Re: Titanium Metals Corporation
Henderson, Nevada Facility
NDEP Facility ID # 000537
Semiannual Groundwater Monitoring Report – 2nd Semester, 2010
Response to NDEP's June 24, 2011 Comments

Attachment A

EXTRACTION WELL: **EWQal-12**

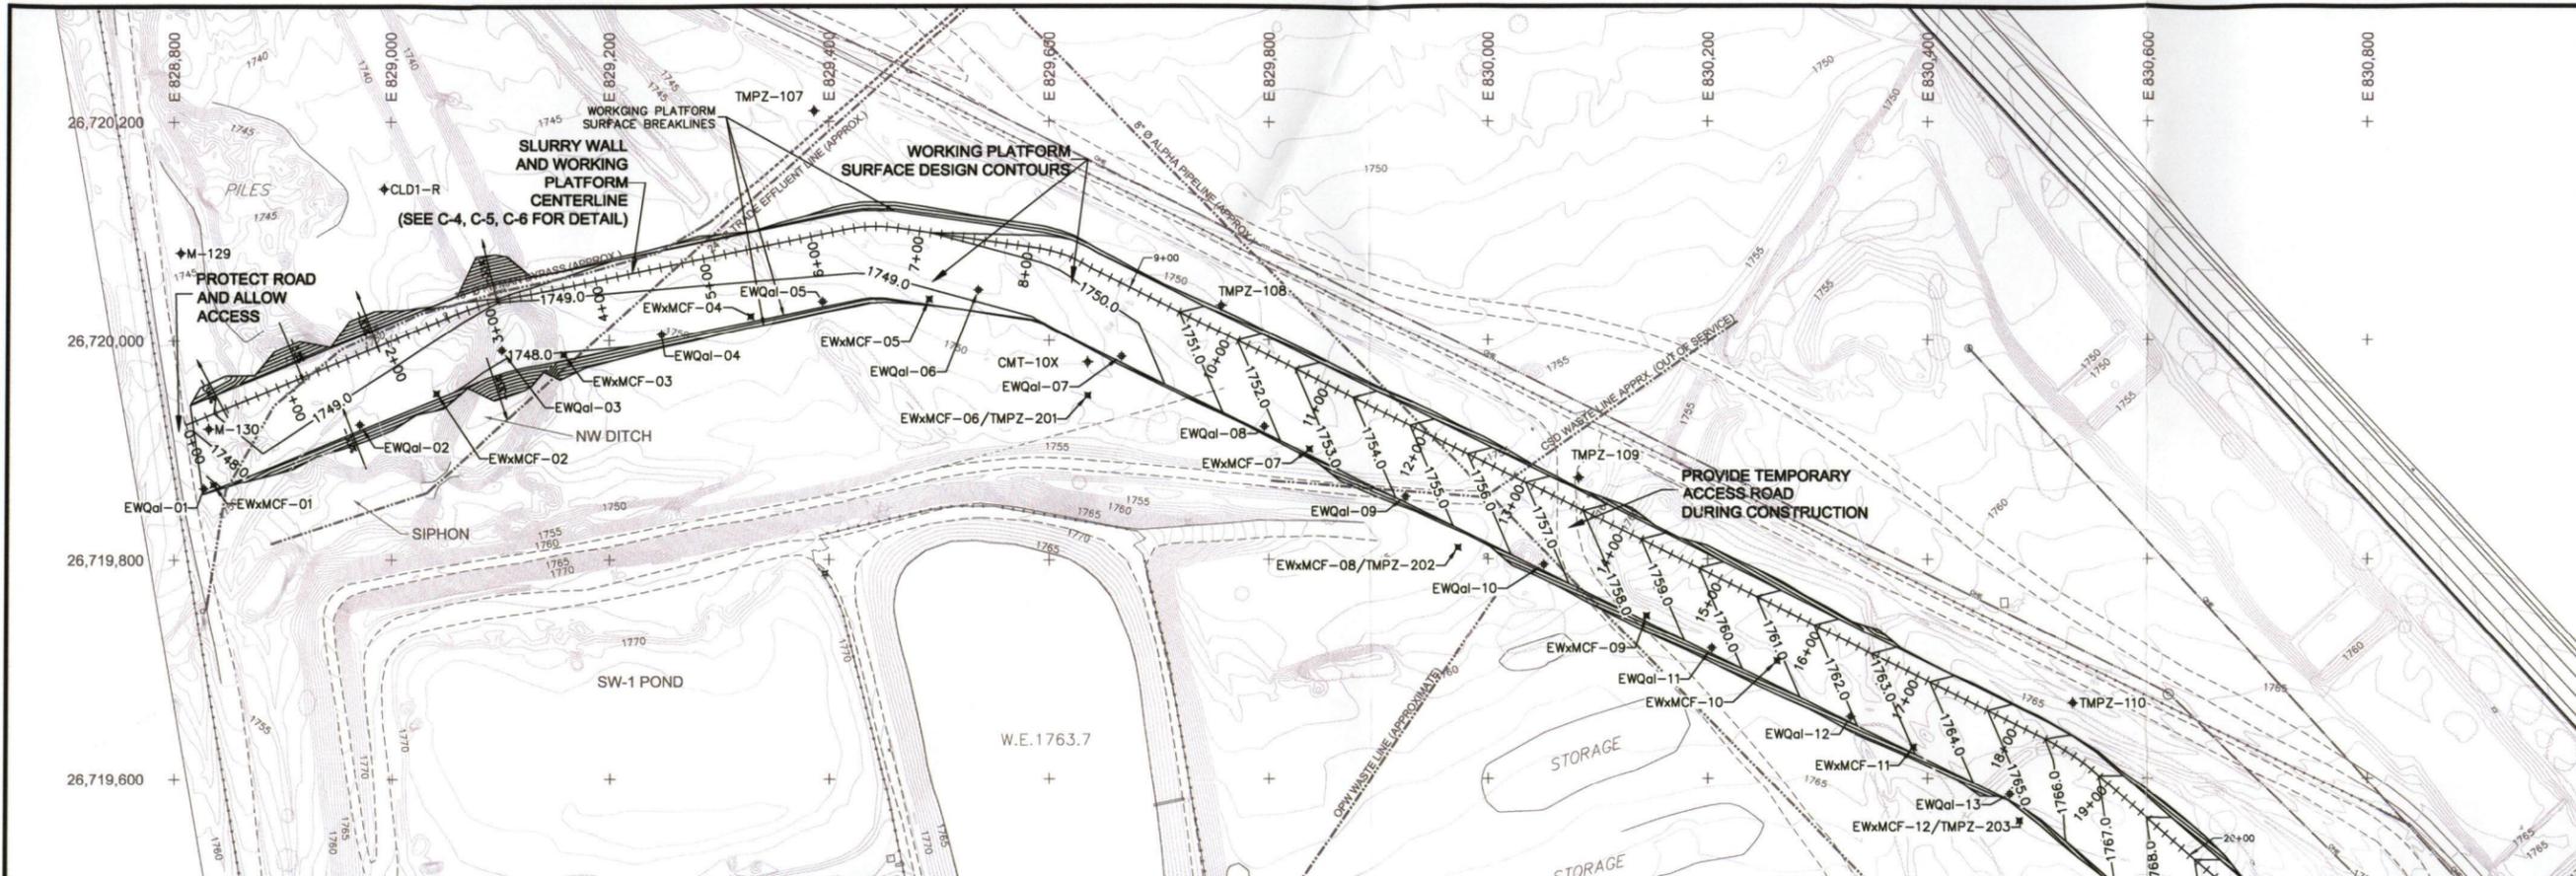
1. Attachment A, response-to-comments (RTCs), NDEP provides the following comments:
 - a. RTC 1, NDEP notes that per the standard operating procedure for low-flow sampling, the sampling rate could be reduced further. Please consider this and discuss.

TIMET Response: After review of the well logs for J2D3-R (the well in question as clarified in our June 7, 2011 response to NDEP's comments), TIMET feels this well, installed in 1983, is no longer screened appropriately for monitoring current groundwater conditions. TIMET proposes to substitute the monitoring of well J2D3-R by monitoring well EWQAL-12; a currently inactive extraction well situated approximately 200 ft north of J2D3-R between TMPZ-109 and TMPZ-110. The well log for EWQAL-12 and a plan view of the well network in this area is attached.
